## HISTORIC AND DESIGN REVIEW COMMISSION

**2017-497**

622 CEDAR ST

Construction of a rear addition and rear porch

RUIZ RESIDENCE  
622 CEDAR ST.,  
SAN ANTONIO, TX 78210  
MAUREEN AND RICARDO RUIZ

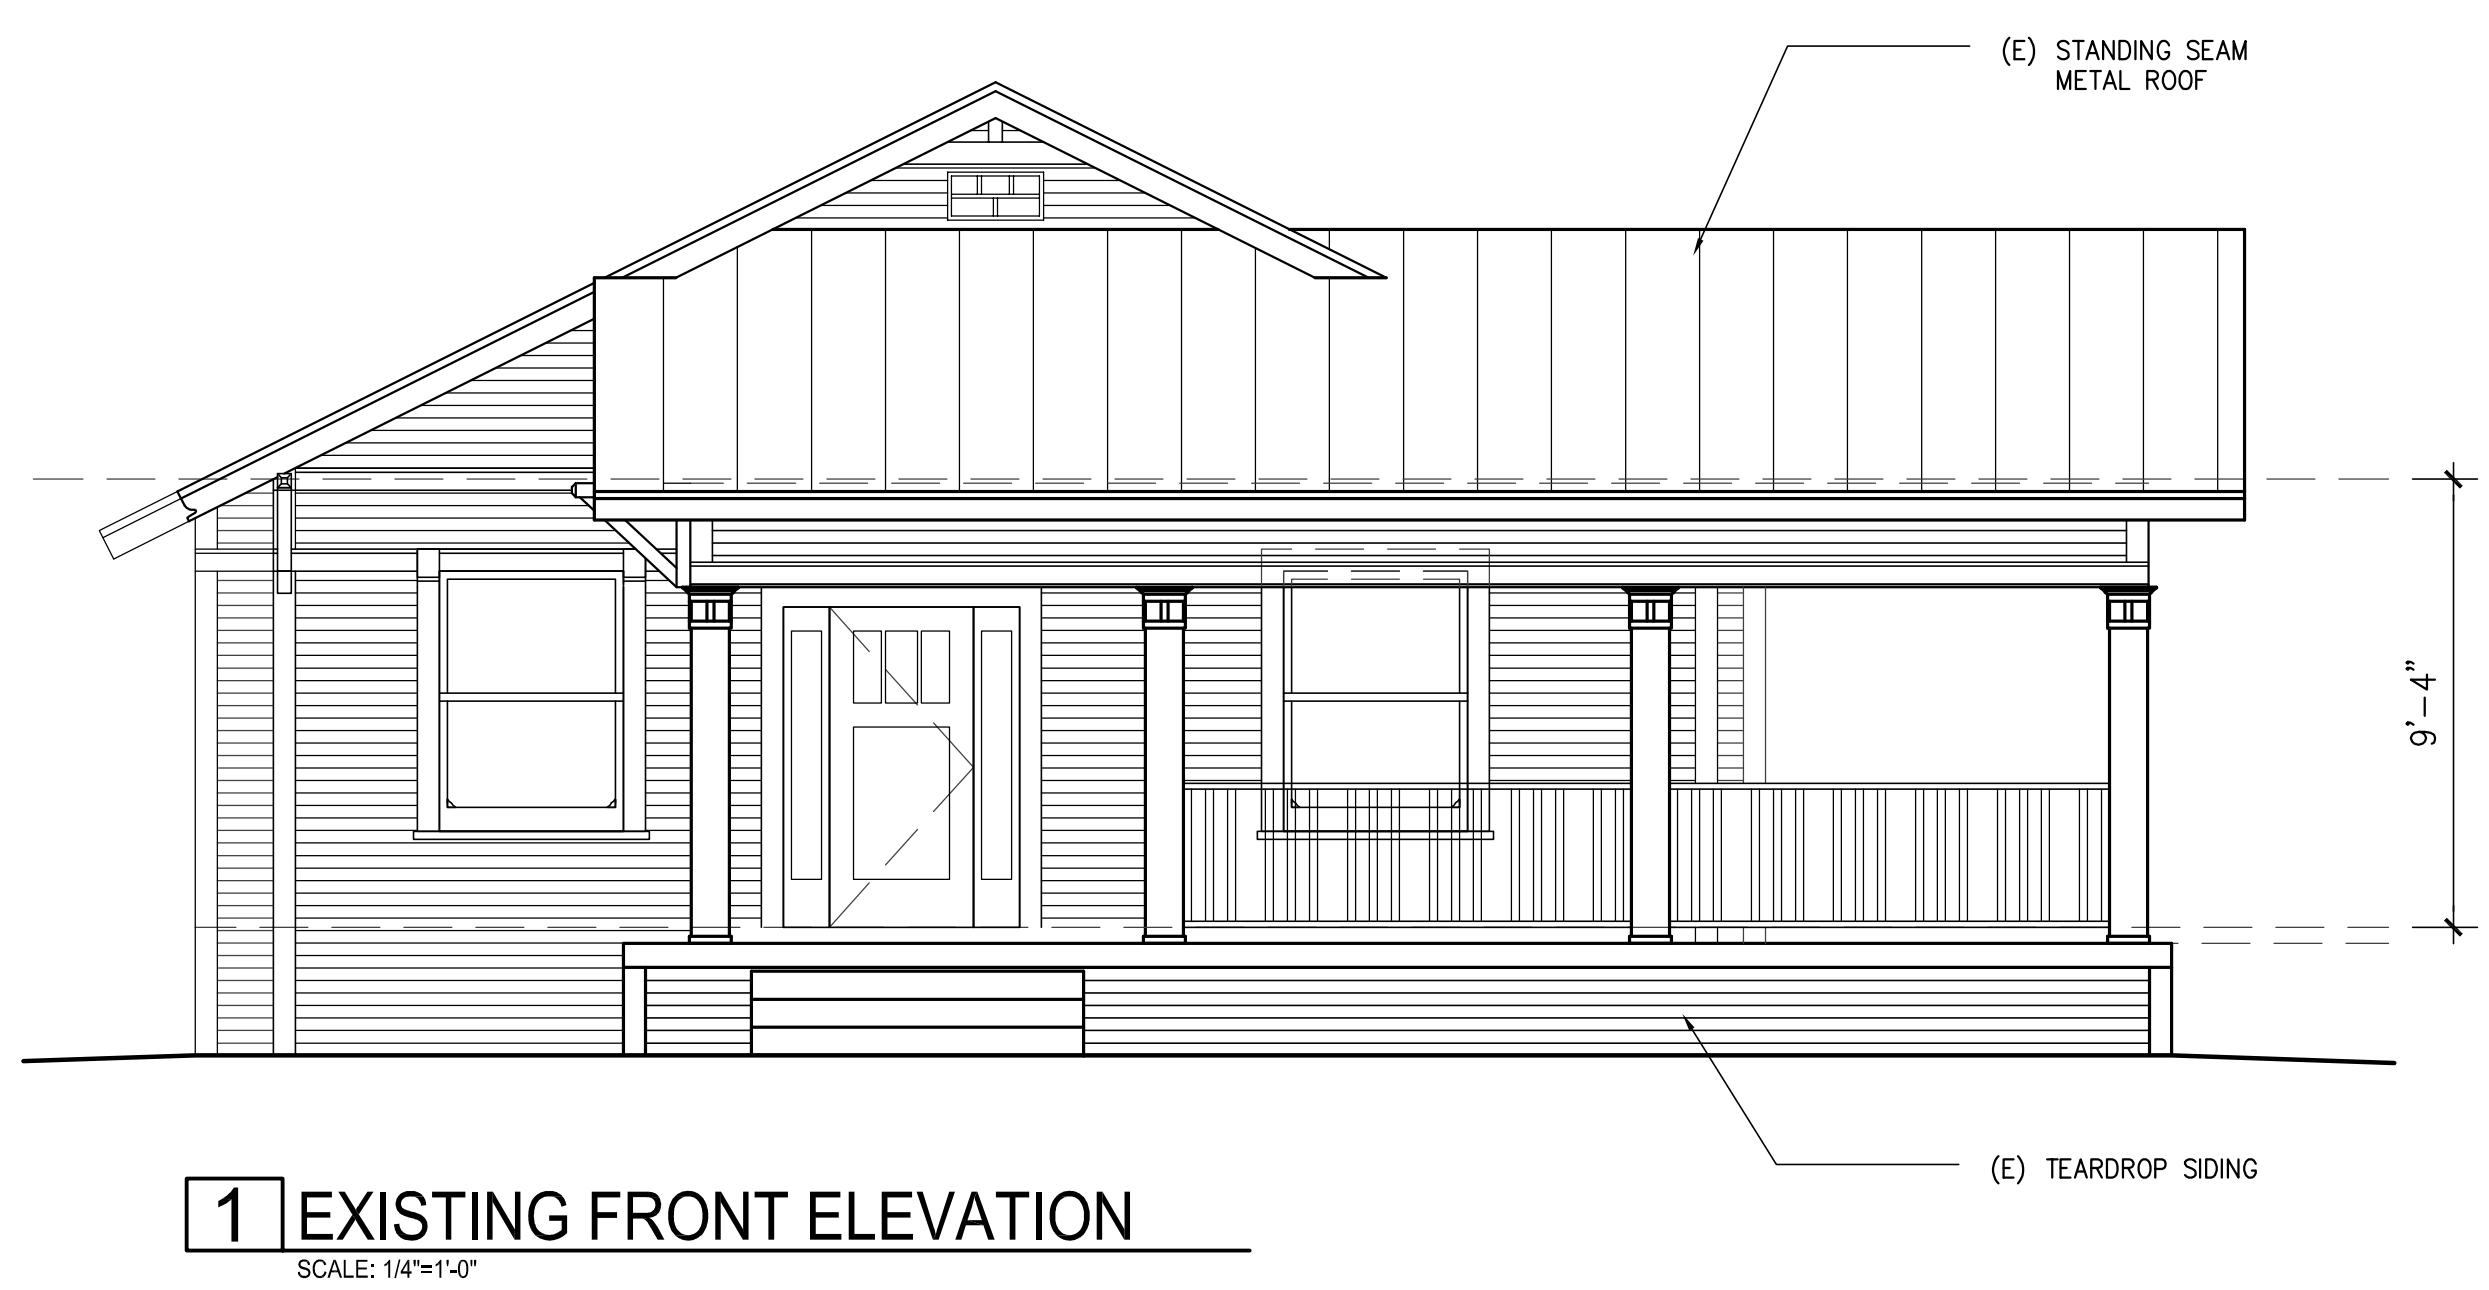
- iii. That the proposed fixed windows on the east elevation be sash windows.
- iv. That the standing seam metal roof feature panels that are 18 to 21 inches wide, seams that are 1 to 2 inches tall, a crimped ridge seam and a standard galvalume finish.
